RE: Proposed S4.55(1a) Application for the Modification of Consent for SSD8440 for Amendments to the Floor Plans for Mixed Use Development (Hotel, Serviced Apartments, Residential and Carpark)

Our Ref: 17058

KDC Pty Ltd (KDC) acts on behalf of its client Doma Holdings (Honeysuckle) Pty Ltd in preparing this supporting Statement of Environmental Effects for the proposed s4.55(1a) modification of consent for SSD8440 under the Environmental Planning and Assessment Act 1979 (EP&A Act) for amendments to the approved floor plans for the mixed use development approved at 42 Honeysuckle Drive, Newcastle NSW 2300.

Figure 3 – Approved Floor Plan and Proposed Modification to Floor Plan

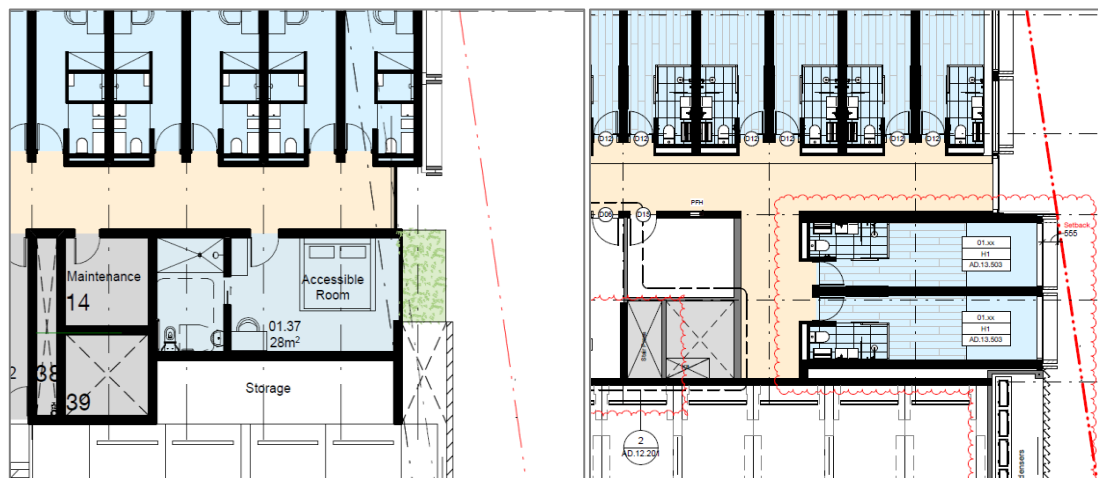
Further changes are proposed to the accessible units (1.37, 2.37, 3.37) on floors 1 to 4 on the eastern portion of the building. It is proposed that the existing single bed accessible unit be altered to contain 2 single bedroom units running on an east/west orientation. It is proposed that the existing inaccessible landscaping currently located to the east of units 1.37, 2.37, 3.37 be incorporated into the floor area of the units. Figure 3 below shows the existing floor plan on level 2, and the proposed floor plan. This format for the units will be replicated on the floors above.

Figure 4 – Approved Northern Elevation and proposed Northern Elevation.

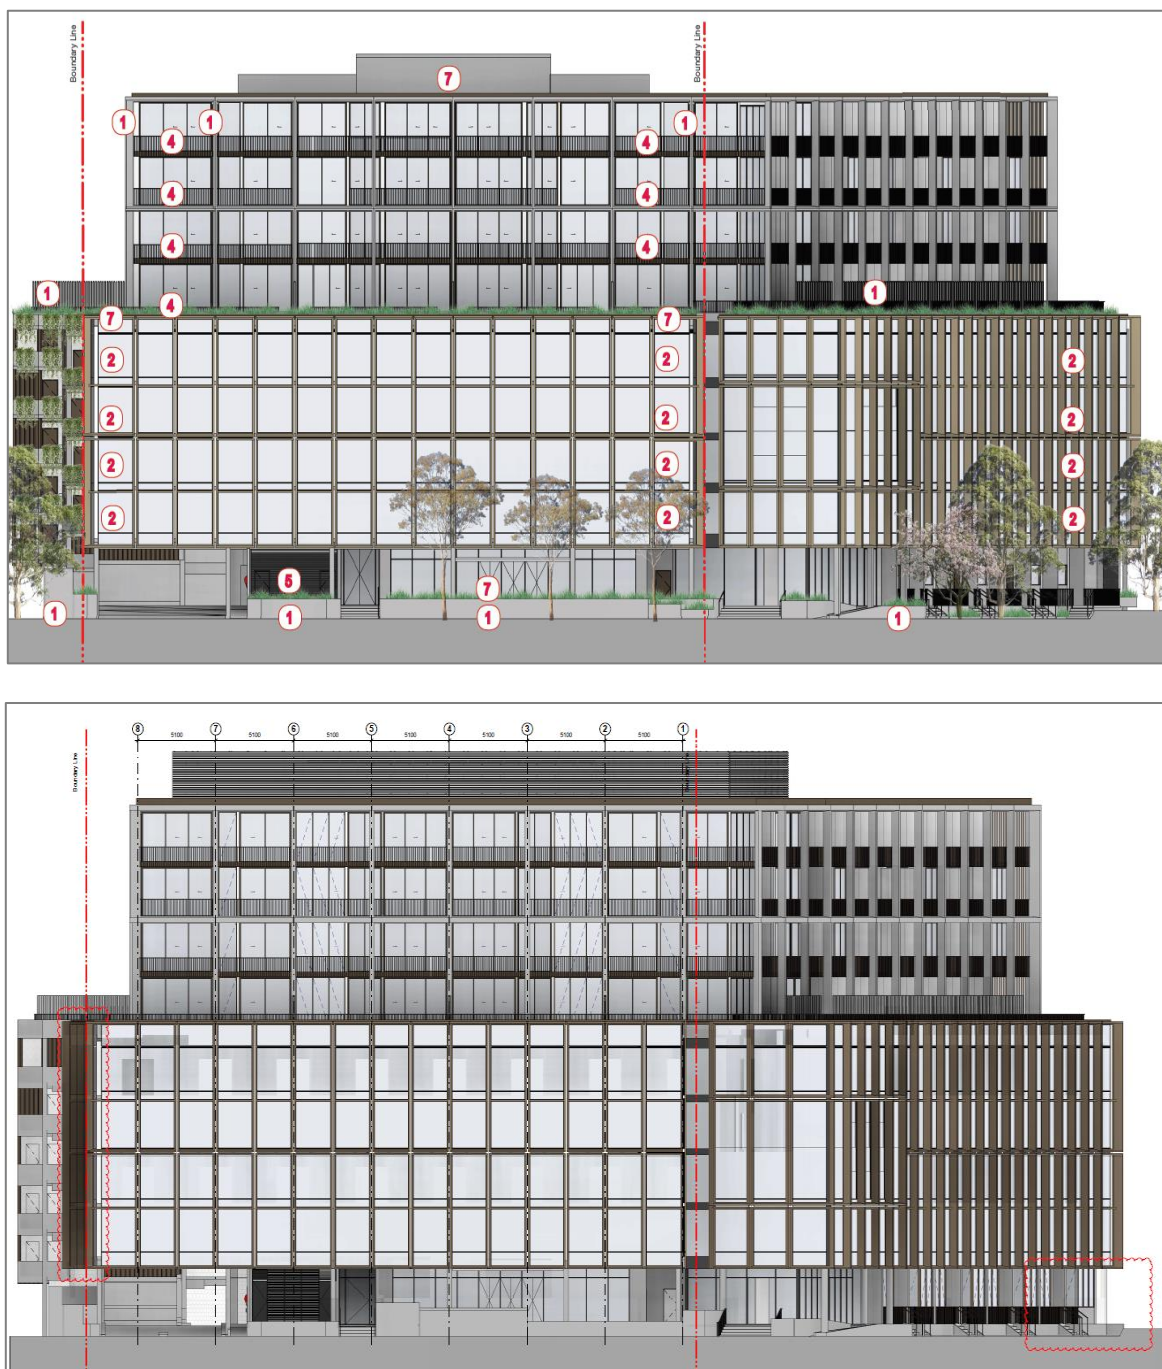
There will be no impacts caused on the visual impact of the building as a result of the proposed modification. The modification is wholly contained within the existing footprint of the building. The impacts that the development will have from a visual impact figures 4, 5, 6 and 7 below demonstrate the minor changes to the elevations showing the minor visual impact.

Figure 7 – Approved Eastern Elevation, and proposed Eastern Elevation

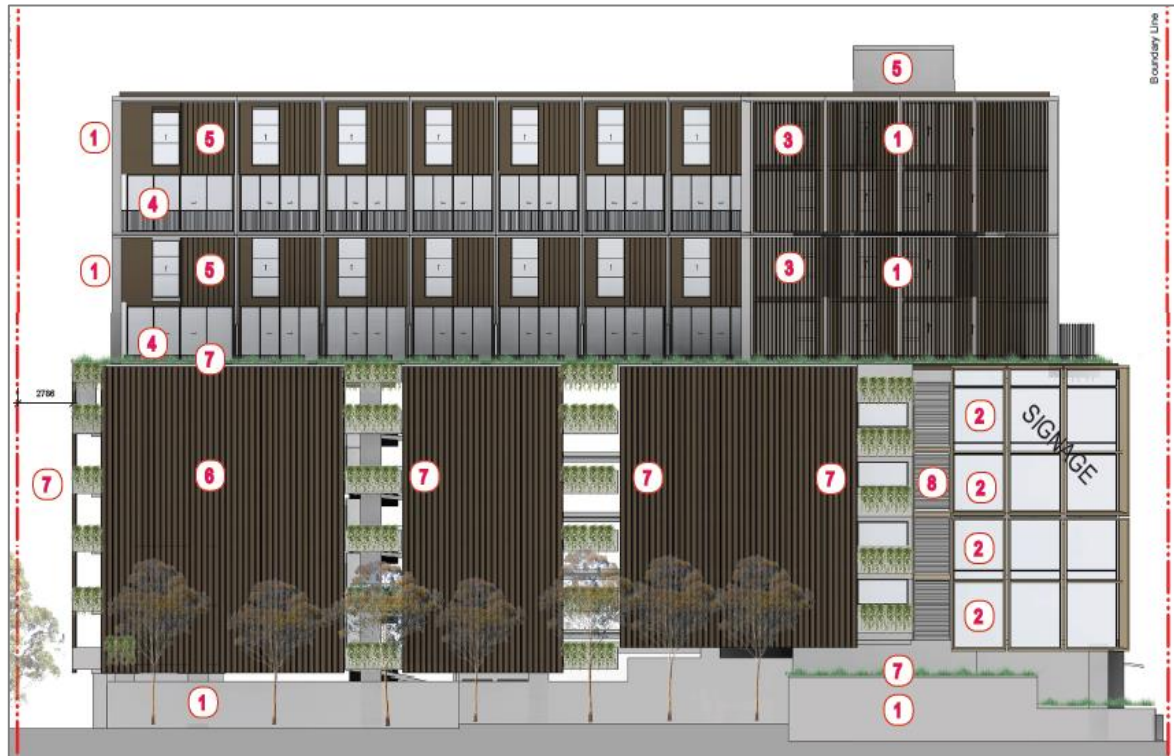
As with the increase in in floor area, there is a minor reduction in landscaping provided. The small landscaping area provided to the east of the units on levels 1 to 4 has been removed so as to not extend beyond the eastern property boundary. The reduction in landscaping is approximately 2m² which is extremely minor in the context of the development as a whole. While the landscaping provided a visual buffer to the hotel unit from the adjoining development, the buffer is considered unnecessary in light that the building separation to the development to the east exceeds 18m, both buildings are commercial, and the building to the east has existing screening on their windows.
